HISTORIC AND DESIGN REVIEW COMMISSION

HDRC CASE NO: 2019-405
ADDRESS: 504 KING WILLIAM
LEGAL DESCRIPTION: NCB 749 BLK 8 LOT 9,10, NW IRR 28.2FT OF 1 & NW 61.2 FT OF 2
ZONING: RM-4,H
CITY COUNCIL DIST.: 1
DISTRICT: King William Historic District
APPLICANT: Daniel Cruz/Design Coop
OWNER: Topher Guerra/LAUREL HEIGHTS FAMILY IRREVOCABLE TRUST
TYPE OF WORK: Construction of a second story porch
APPLICATION RECEIVED: July 17, 2019
60-DAY REVIEW: September 15, 2019
CASE MANAGER: Stephanie Phillips
REQUEST:

The applicant is requesting a Certificate of Appropriateness for approval to construct a second level wrap around front porch. The porch railing will be constructed with simple wooden balustrades and feature

Seam on stone face, indication of possible wrap around porch at one time.

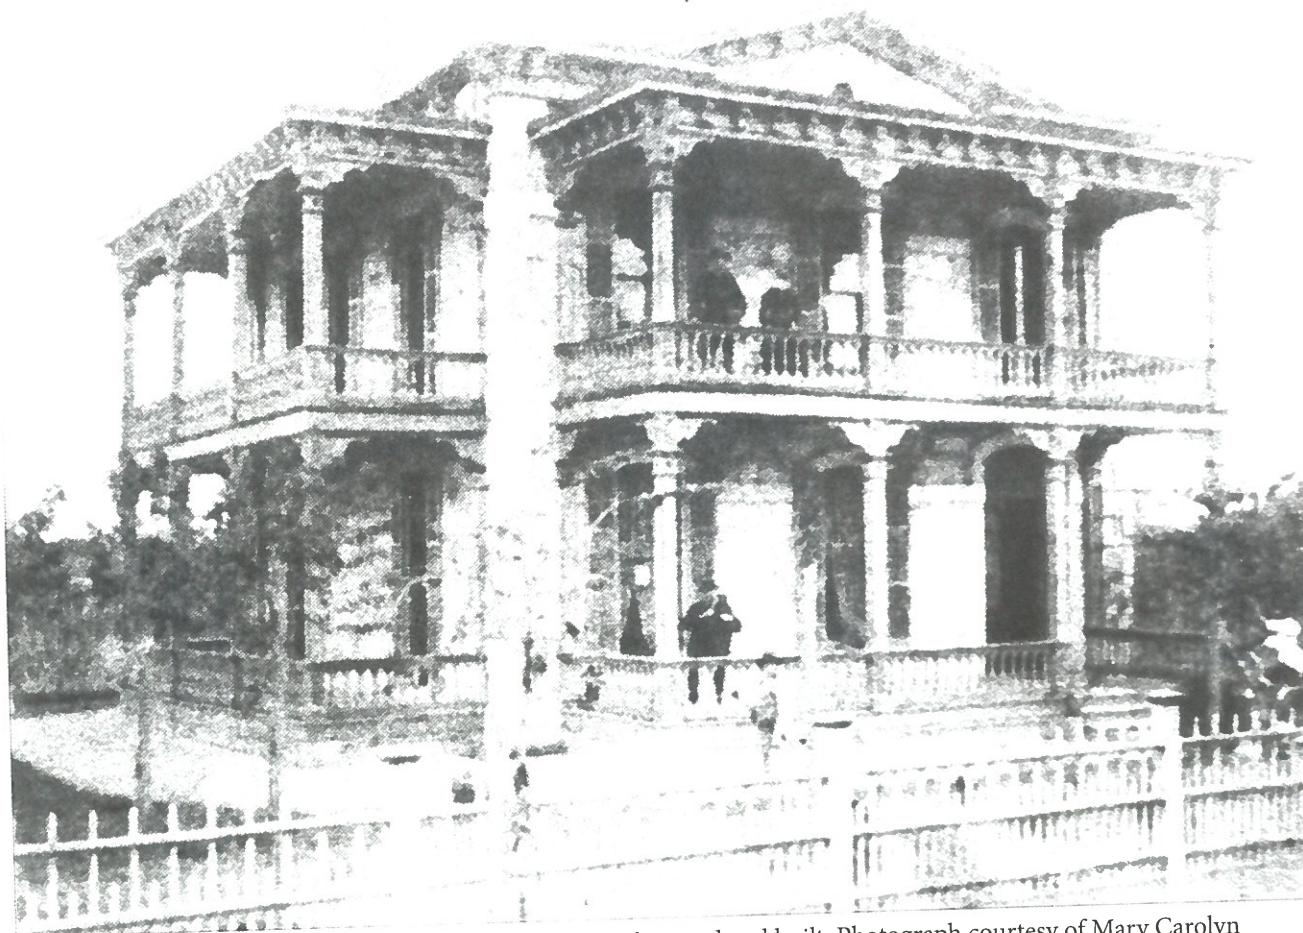
- c. LOCATION – The applicant has proposed to construct a second story wraparound porch. The porch will extend from the central front façade towards the rear of the structure, on the northern side elevation. The existing case stone decorative frieze above the front door will remain. Based on historic photographs of the structure, a wraparound porch existed previously in this location. Based on this evidence, staff finds the general location consistent with the Guidelines.

ELEVATION: GUARDRAIL
SCALE: 1 1/2" = 1'-0"

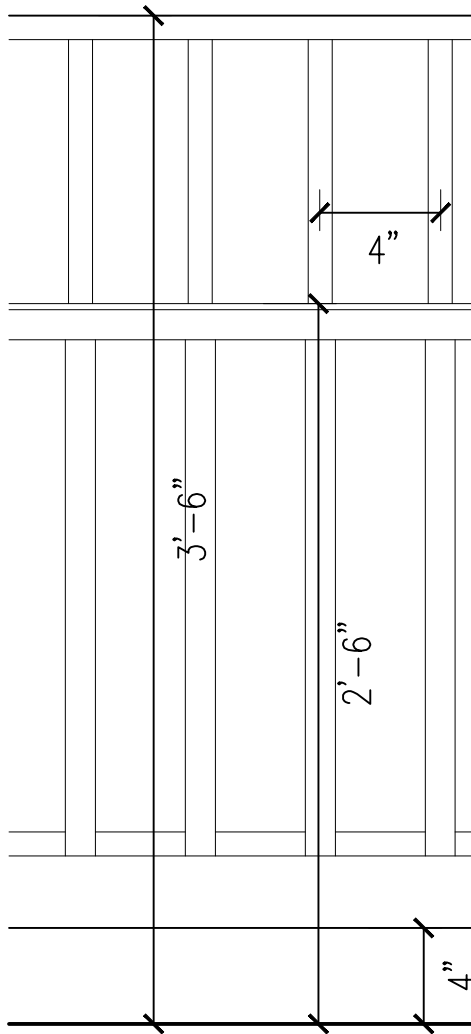
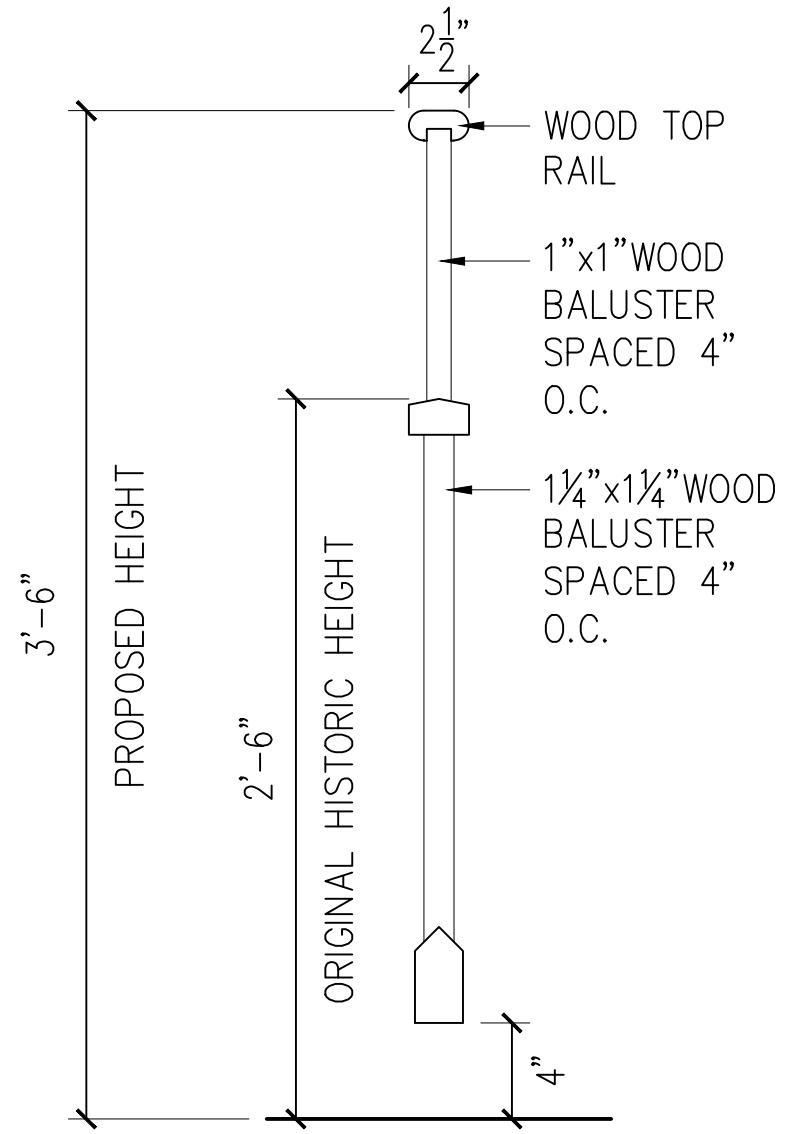
- d. DESIGN – The applicant has proposed a wooden guardrail and composite decking for the porch floor. The supportive floor substrate is not indicated on the submitted plans. The guardrail will be a simple wooden post design with a rail at the historic height (approximately 2’-6”) and a smaller baluster and rail atop for a total height of 3’-6”. The bottom balusters will measure 1.25” square with a spacing of 4” and the top balusters will measure 1” square with a spacing of 4”. According to the Historic Design Guidelines, porches should be reconstructed based on accurate evidence of the original, such as photographs. If no such evidence exists, the design should be based on the architectural style of the building and historic patterns. Staff finds that the design as proposed is not consistent due to the photographic evidence of the previous porch. Staff finds that the applicant should restore the porch to its 1915 configuration, including the inclusion of wooden turned balustrades at their original height. The applicant may install a second guardrail structure, secondary in design and location, to achieve minimum code requirements.

Staff does not recommend approval of the porch modifications at this time. Staff recommends that the applicant propose a second story porch addition that restores the structure to its 1915 configuration as evidenced by archival photographs as noted in finding d.
